**ADDENDUM 01**

Addendum #	01	Date Issued	03/21/2025
Project Name Job #	SWN 0509, Waneta Hall Renovate Restrooms	OSE #	R0325--15X
		EAPC #	20256780
Bid Date Time	April 3, 2025		3:30pm

PROJECT DESCRIPTION
SWN 0509, WANETA HALL RENOVATE RESTROOMS (OSE# R0325--15X)

DRAWING TITLE
 CRAWL SPACE PLUMBING PLANS

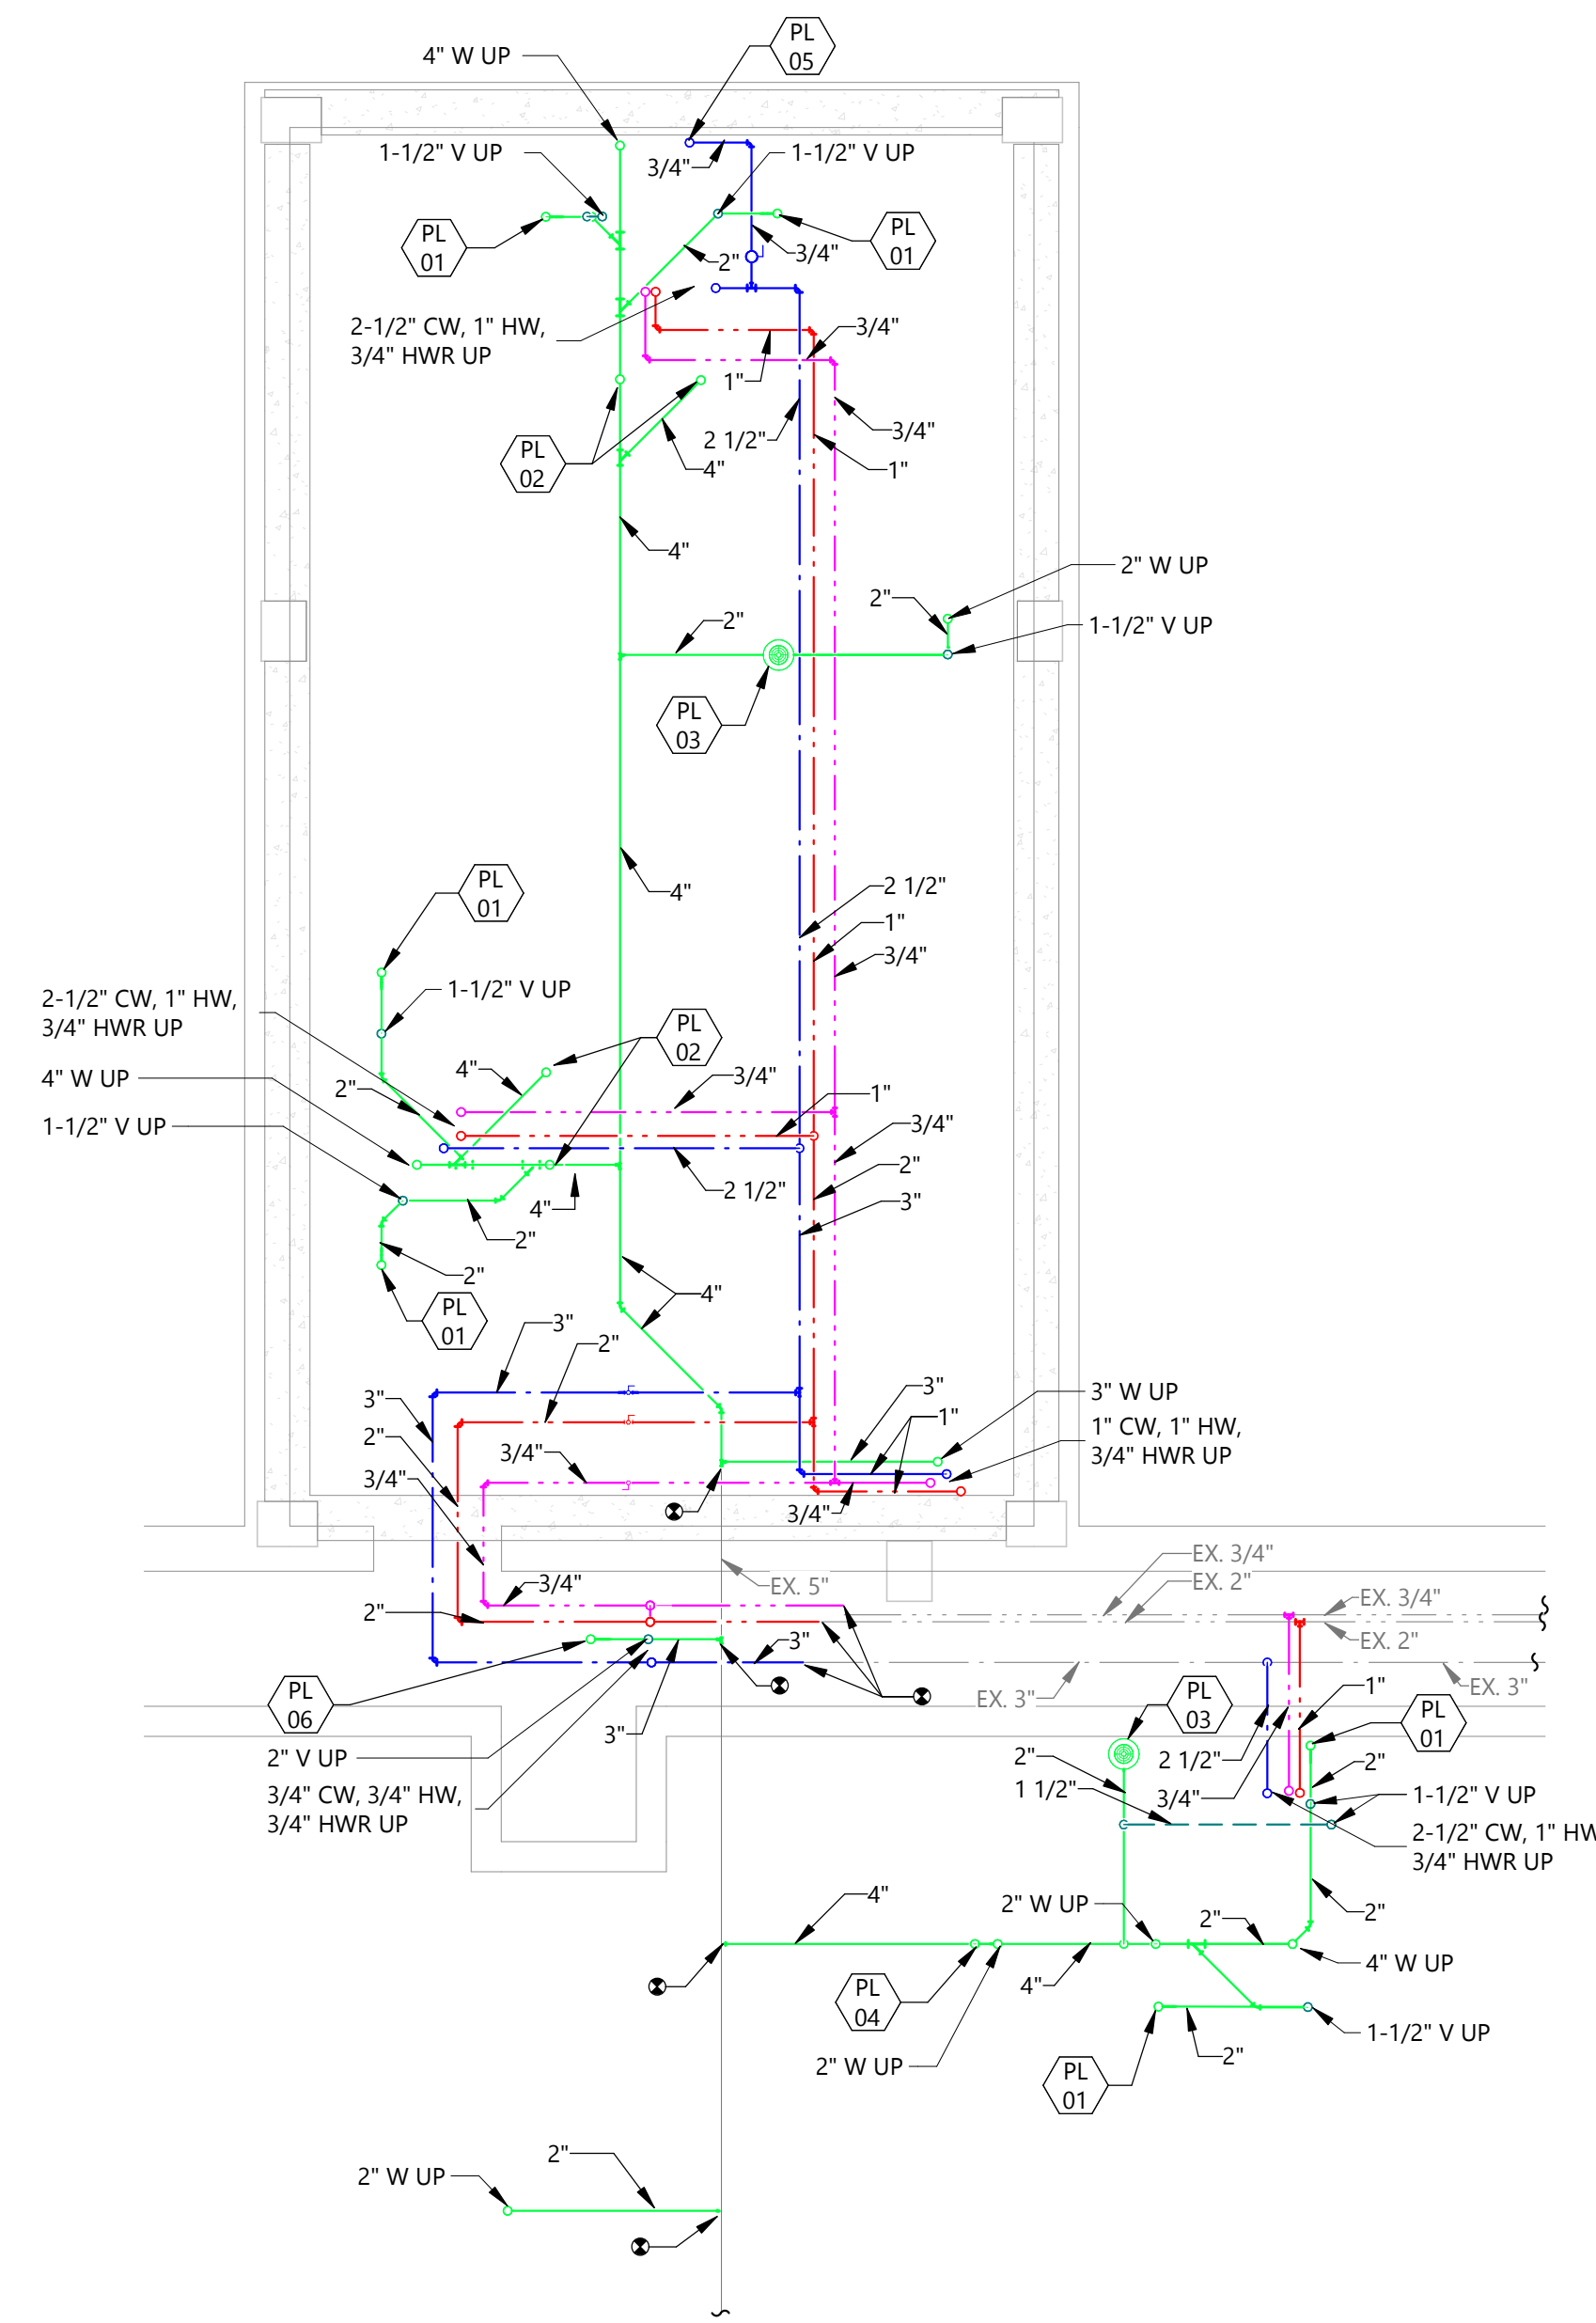
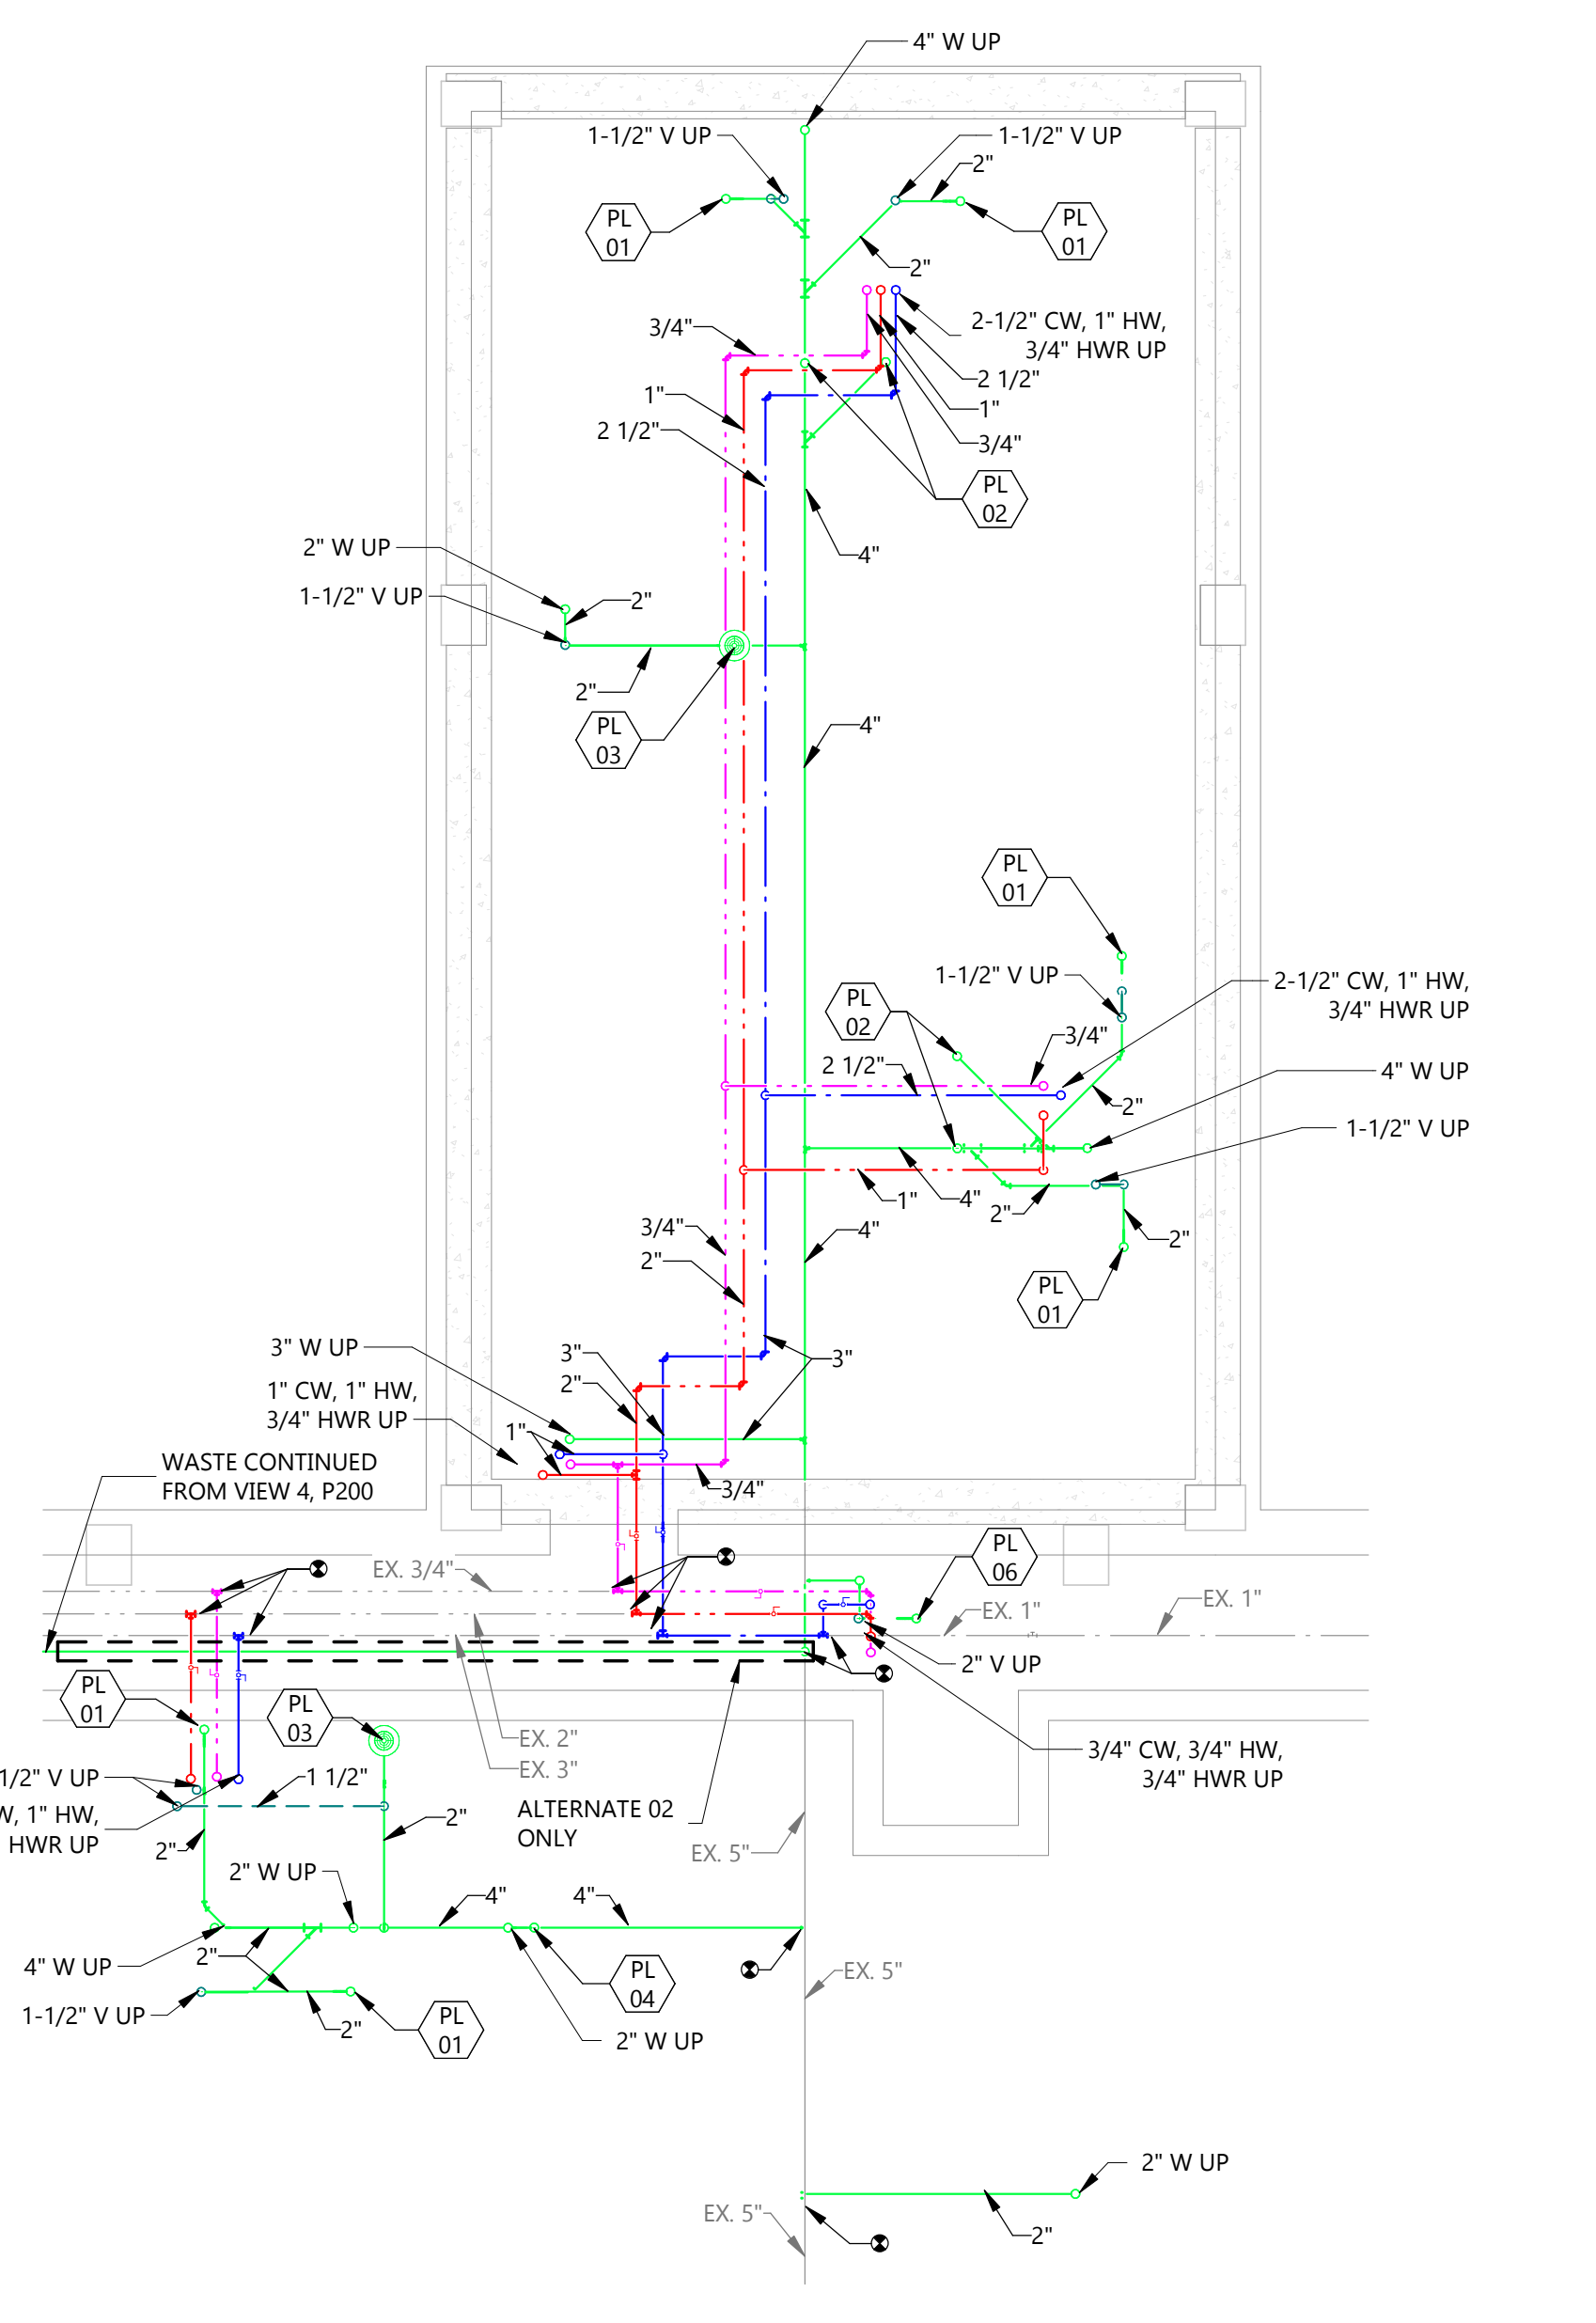
P200	REVISE plumbing pipe routing to stay within tunnel space regarding Alternate 02 work.
P201	REVISE plumbing pipe routing in wall associated with Alternate 02.
M201	REVISE ERU's and associated ACCU's locations for concrete pad and clearances.
M301	REVISE ERU and ACCU locations for concrete pad and clearances. ADD section view for ductwork installation.
E101	CLARIFIATION on existing panel names.
E102	CLARIFIATION on panel names.
E103	CLARIFIATION on panel names and demo at RM 326.
E200	ADD location for MDP.
E201	ADD location for mechanical equipment and duct smoke detectors. Add clarification on alternates. REVISE power at alternates ADD notes 5 and 6.
E202	ADD clarification on alternates. Add notes 3 and 4. REVISE power at Study rooms
E203	ADD note 4 for data rough in. Update power at Study rooms
E301	ADD clarification on lighting types and occupancy sensors.
E302	ADD clarification on lighting types and occupancy sensors.
